Our Ref: 27594-062-01
Council Ref: AP2024/013
QA: es

RESPONSE TO INFORMATION REQUEST (REFERRAL ENTITIES) – AP2024/013
Development Permit for Reconfiguring a Lot – Boundary Realignment (8 Lots into 4 Lots) combined with Material Change of Use for Warehouses in the Townsville State Development Area (SDA)

PROJECT NAME:
TOWNSVILLE NEW WAREHOUSE AND OFFICES

SHEET NAME:
PROPOSED FLOOR PLAN - LOT 01 & 02

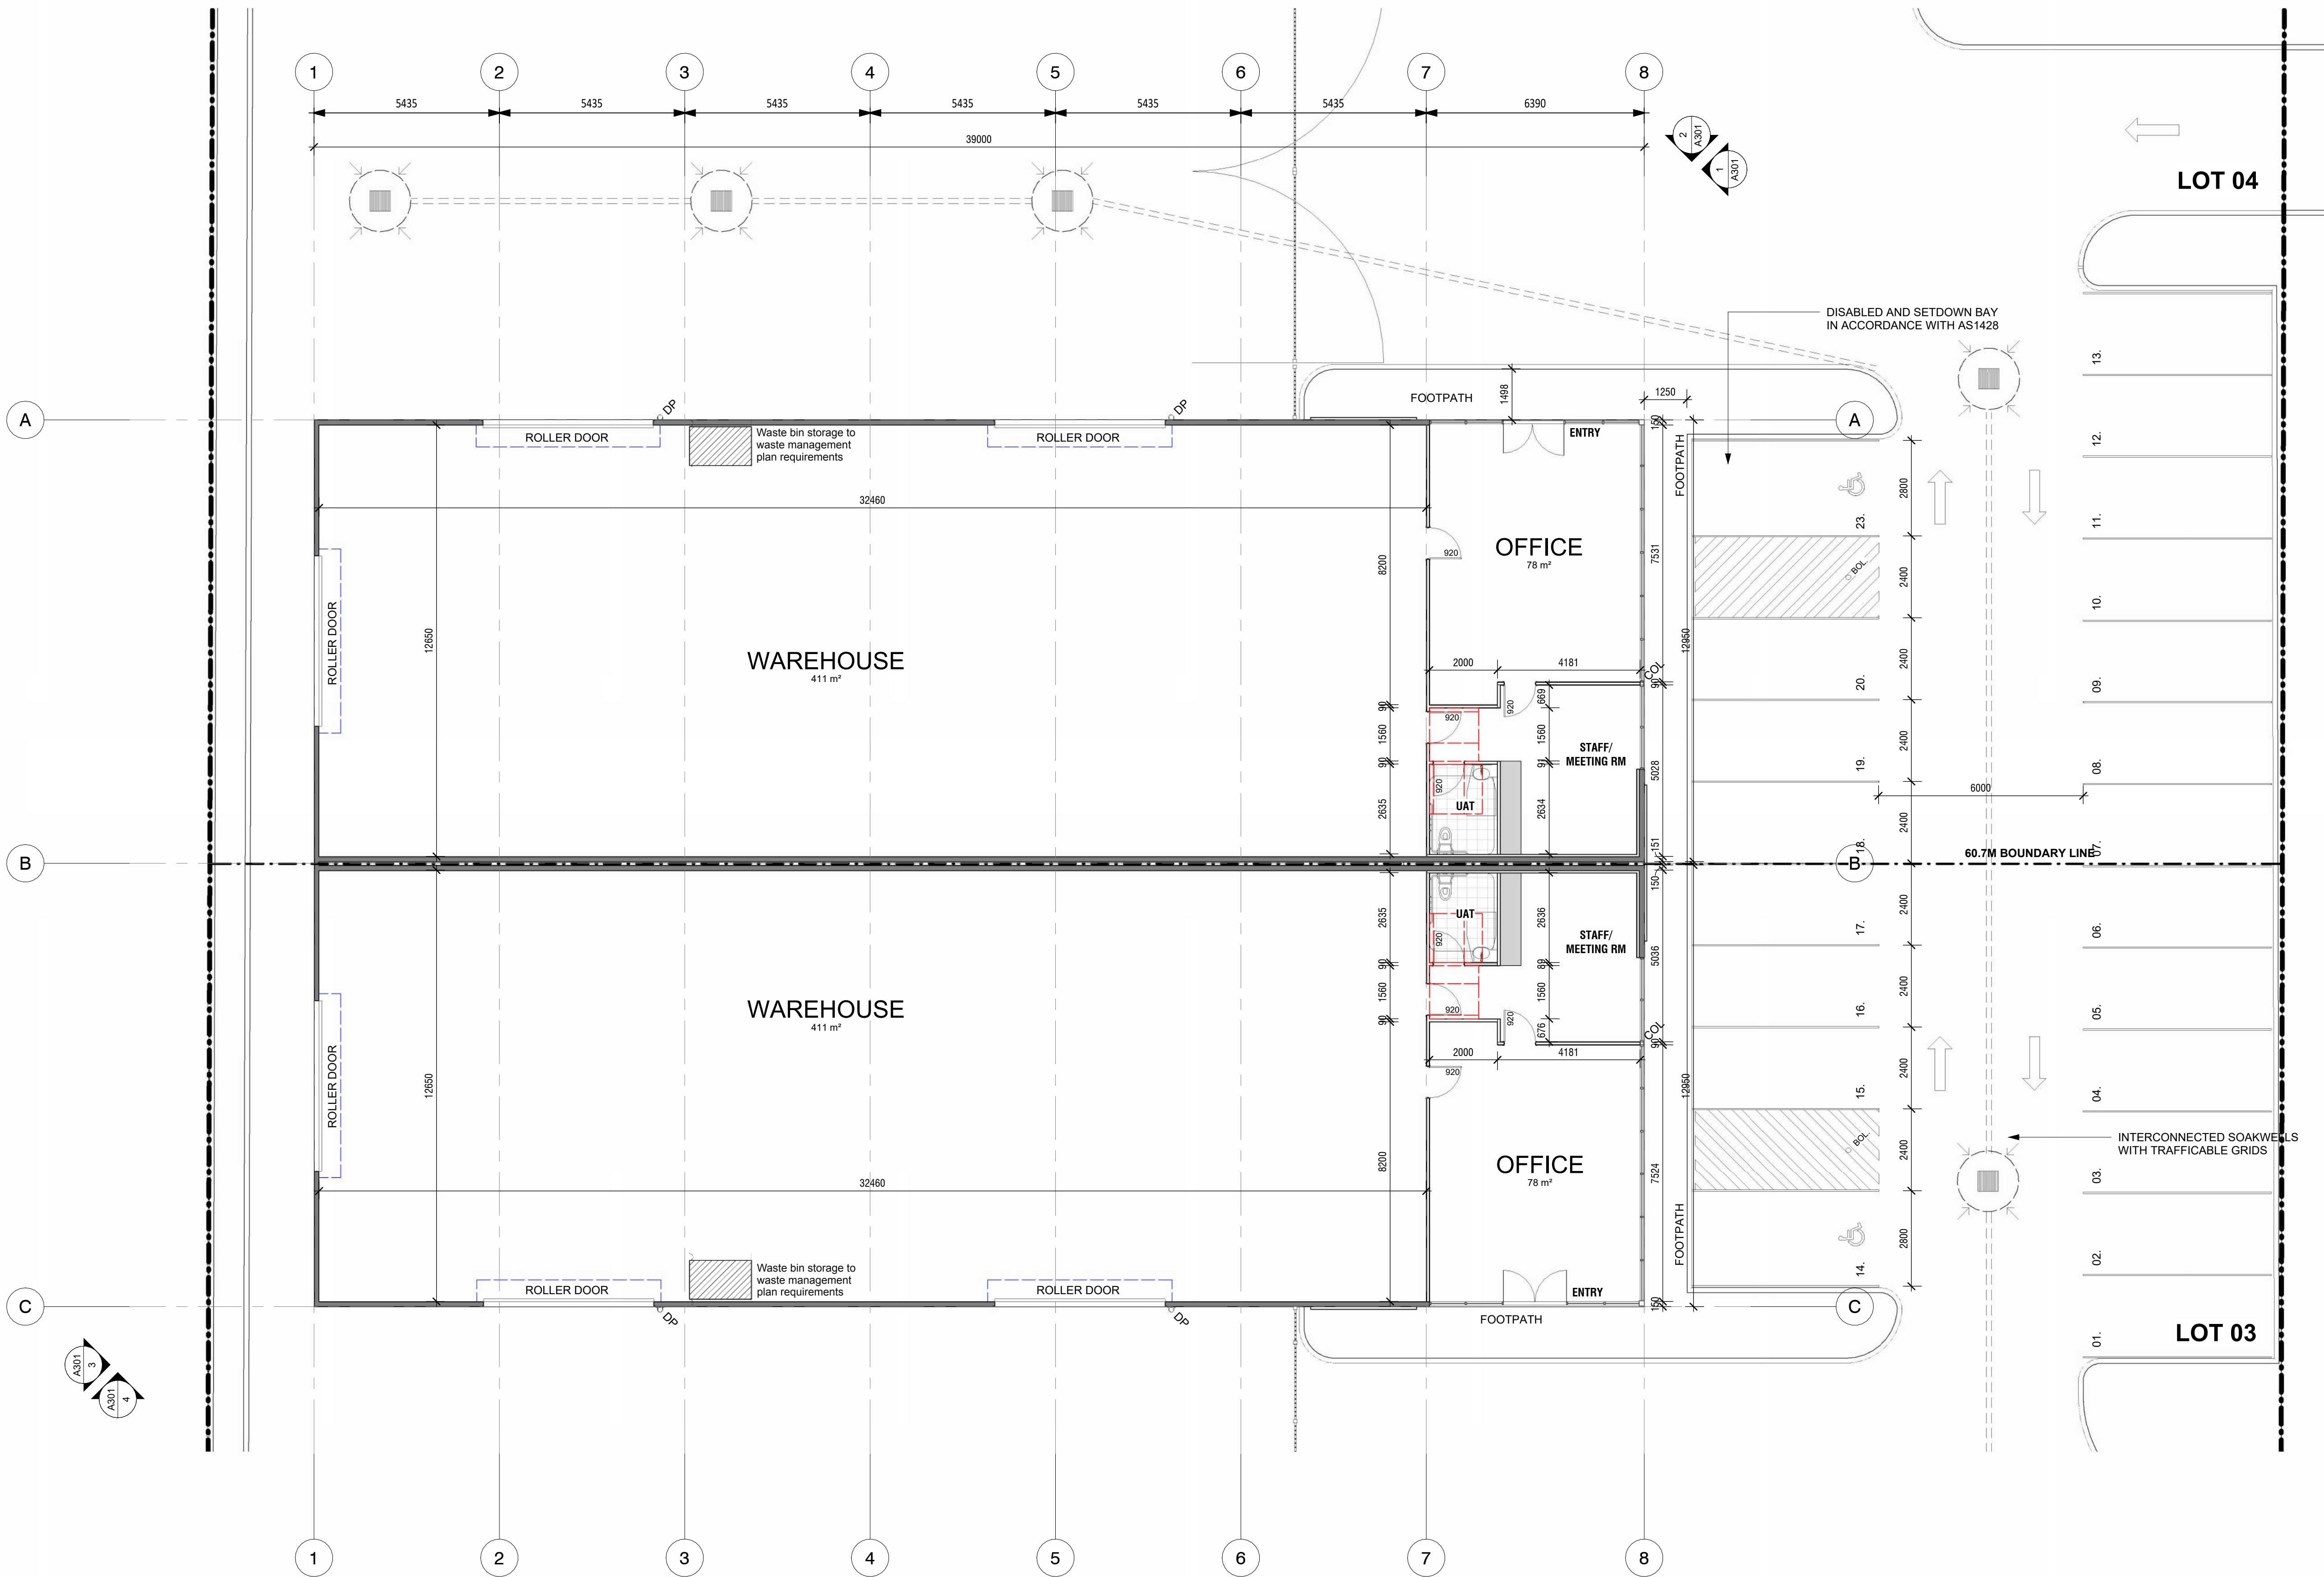
No.	Issue	Information Requested
Traffic impacts		
1	Traffic impact assessment	The traffic impact assessment report prepared by Cardno in 2013 for a nine (9) Lot subdivision is not considered satisfactory for the proposed development. Notwithstanding the adopted traffic generation estimates and GFA estimation within the Cardno report, the proposed development must be assessed for impact of proposal on the surrounding transport infrastructure to identify any upgrades that may be required, more specifically, to Jurekey Street. It is noted that upgrades to Jurekey Street that have been approved in a separate SDA approval (AP2024/017) have not yet been undertaken and it is unclear of the timing of these upgrades relative to when the current proposal will be undertaken. The proponent is requested to provide an updated traffic impact assessment in accordance with the requirements outlined in SC6.4.5.2 Traffic impact assessments (TIA) of the Townsville City Plan. This should include: • an analysis of the existing traffic operating conditions, traffic volumes and turning movements counts for peak periods for the sections of the network surrounding the development • an assessment of all intersections that have an increase in traffic volume of more than 5% over and above the existing traffic volume as a direct consequence of the development • demonstrate waste management provision for each lot including bin location and access to the bin locations by a service vehicle.

Furthermore, the development plans have been updated to identify the location of bin pads within the warehouses to demonstrate waste management provision for each lot. Access to these bin locations by a service vehicle has been previously demonstrated on the swept path analysis prepared by Brazier Motti.

Figure 2-4 1% AEP WSL Afflux

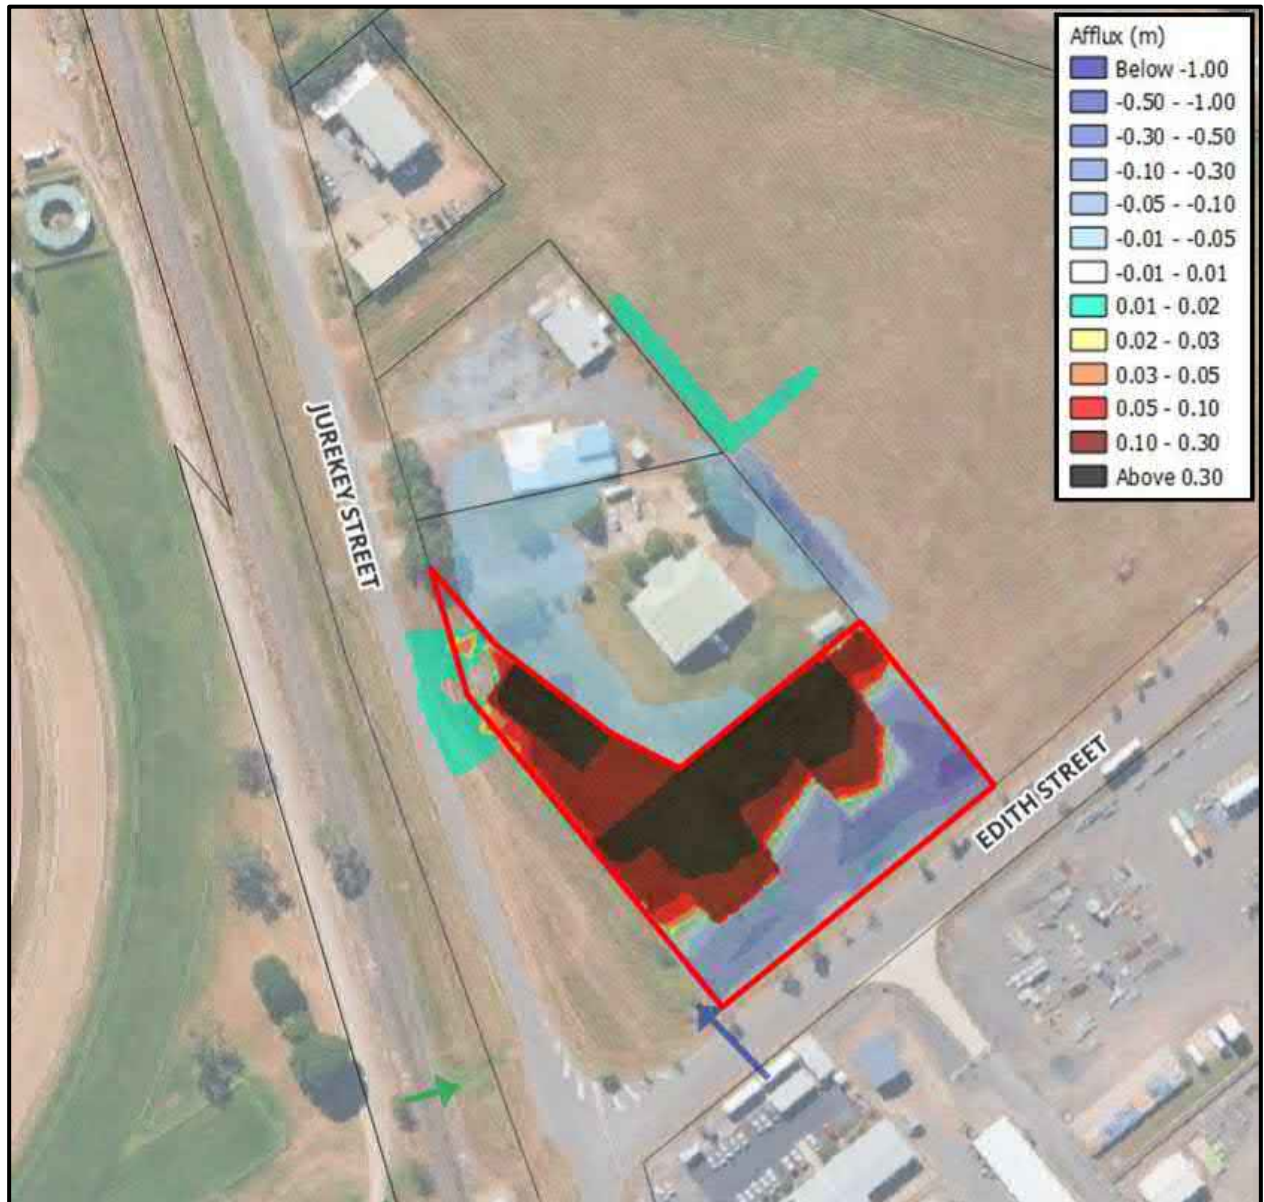
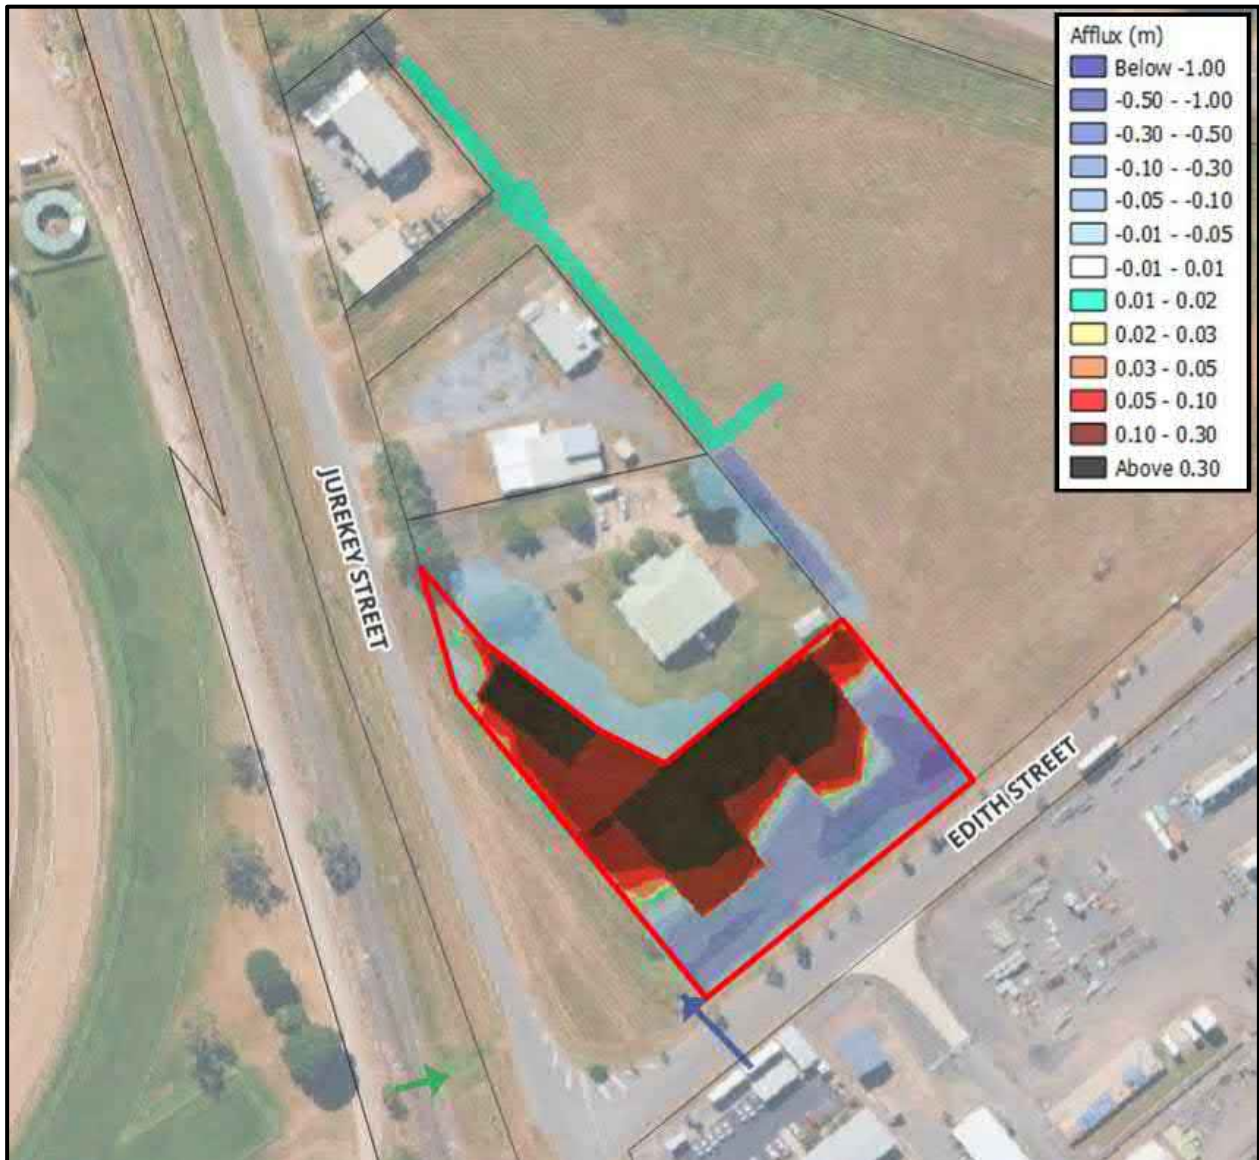
surveyor, to verify the existing drainage characteristics of the site. All legal points of discharge for the development site should be identified. b) <i>Detention design</i> – provide a conceptual design for the proposed stormwater detention solution and supporting hydraulic/hydrological analysis and calculations to demonstrate that it will be adequately sized/have sufficient capacity for all relevant design events. This should include a layout/design plan, sections, cross sections, longitudinal sections (where relevant), elevations and outlet design with clear levels and volumes shown. c) <i>Water quantity assessment</i> - the peak discharge analysis should be updated to show the mitigated flows from the site for each legal point of discharge (including flow types). The design flood peak discharges should be shown for the mitigated case to demonstrate there is no worsening impact on the railway corridor.

The resulting development impacts are shown in **Figure 2-4** and **Figure 2-5** for the 1% AEP and 20% AEP respectively. Afflux is defined as the relative change in a flooding characteristic, namely water surface level (WSL) or velocity, between the baseline and developed scenario. This is determined by subtracting the baseline peak results from the developed peak results, where a positive value represents an increase in the flood characteristic and a negative value is a decrease.

The above afflux mapping shows no impacts on the adjacent railway line to the west, no afflux over the adjacent roadways and no afflux on adjacent lots. Some highly localised, minor afflux is noted in the 1% AEP event through the Jurekey Street road reserve however, this is extremely minor and does not impact on the roadway trafficability or change the hazard level. Some afflux is generated through the easements on the adjacent lots owned by Toprise to the north-east in both events.
